**SUBJECT: Comment Letter: Draft Policy for Toxicity Assessment and Control**

### CLEAN WATER ASSOCIATION TECHNICAL COMMENTS PROPOSED POLICY FOR TOXICITY ASSESSMENT AND CONTROL

**Figure 1.** Fathead minnow survival effects between 0% and 25%. All tests conducted by the Districts San Jose Creek Water Quality Laboratory in 2009.

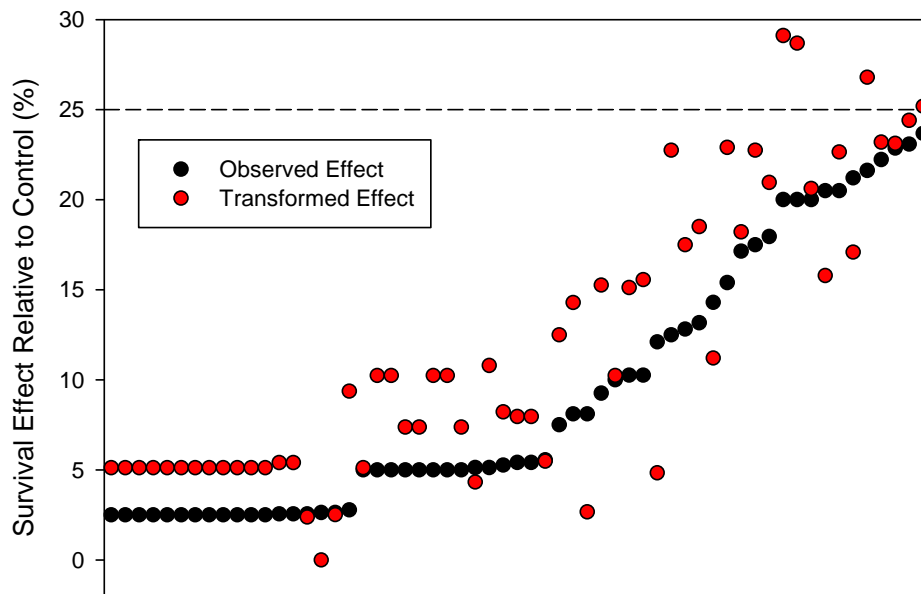
**14. The Arc-sine Square Root Transformed Data Contains an Apparent Bias.**

Transforming percentage data (e.g., survival responses) is a commonly accepted practice prior to conducting hypothesis testing where normal distribution assumptions are critical in the statistical analysis. When using the commonly applied arc-sine transformation, a bias resulting in the calculated response or effect using the transformed data is typically greater than the actual observed response of effect. This bias poses little concern when traditional hypothesis testing is conducted because all transformed treatments are compared directly to the transformed control. However, with the TST hypothesis test, the transformed treatments are compared to 75% of the transformed control. By not similarly transforming the binomial “b” or bioequivalency factor (75% for chronic tests and 80% for acute tests), this bias will significantly increase the probability of identifying a sample as toxic. The effect and magnitude of this bias in real world samples exhibiting observed effects ranging from zero (0) to 25% are presented in Figure 2.

After reviewing the EPA's TST spreadsheet tool (version 1.5), it is clear that all effects are to be calculated using original, not transformed data. Considering that there is significant positive bias associated with calculating percent effects at the IWC using transformed data, EPA TST tools calculate percent effects using untransformed data, and that accurate calculations of these estimates are critical for reasonable potential determination, MDEL evaluation, and TRE trigger determination, all references and examples in the Revised Draft Policy should clearly indicate that original units are to be used for these calculations.
